City of Portland, Maine - Building or Use Permit Application

Permit No: 04-1757	Issue Date: DEC 22 2004	CBL: 304 B032001
-----------------------	----------------------------	---------------------

Proposed Use: Commercial Sign / Auto Repair Shop / install 2 5'9" x 8'1" signs - pole sign withdrawn from application by James Spinelli 1212104	Proposed Project Description: Auto Repair Shop / install 2 5'9" x 8'1" signs - no pole sig, only bldg sign approved
---	---

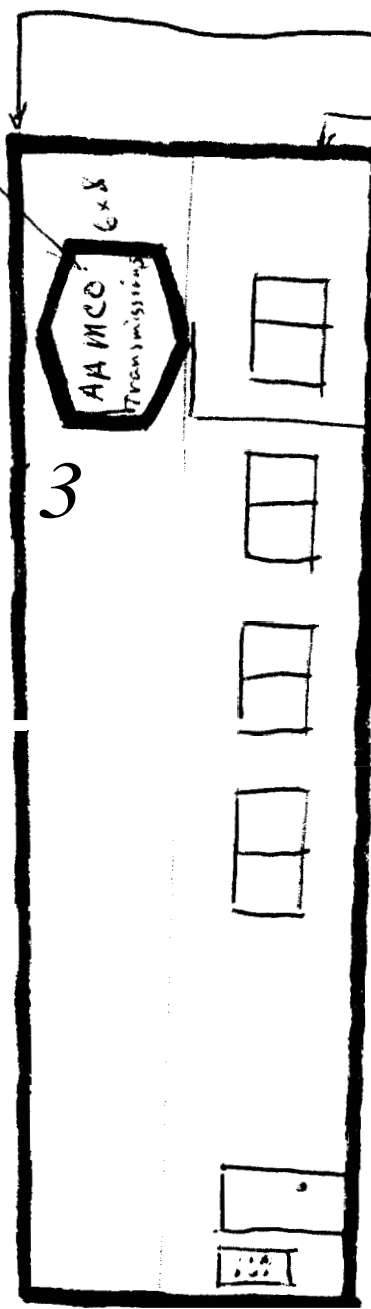
Wall Mounted on Side of Building
 Withdrawn by owner
 James Spinecci
 12/2/04

Two Bolted 3/4" x 8"
 Sheet metal / steel studs
 into 2x6 & structural
 steel
 per James Spinecci
 12/21/04

2nd free standing sign
 NOT PART of
 This permit
 Approved Pole
 4' below ground

- 1) It is understood that the proposed freestanding sign is withdrawn from this application. It is considered to be a 2nd free standing sign which is not permitted by ordinance. This approval is only for the proposed sign attached to the building.
